AGENDA

PARK CITY MUNICIPAL CORPORATION
HISTORIC PRESERVATION BOARD
MINUTES OF JANUARY 16, 2013

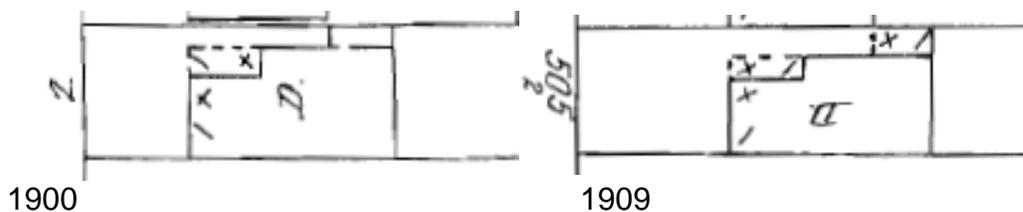
6. Historic Buildings (sic) Structure and roof forms are not being preserved or retained.
(Numerous HDDG are either disregarded or outright violated)

The Board requested additional information from the applicant and continued this item of the appeal. The Board requested additional visual analysis of the addition as it relates to the historic house including a streetscape view to review the

streetscape, specifically related to the “string-line” analysis of the heights of the adjacent houses.

The applicant has provided additional visual analysis as viewed from both the primary right-of-way and across the “valley” as another way to analyze the visual impact of the addition on the rhythm and scale of the streetscape. This analysis gives a view of the streetscape as seen from a distance.
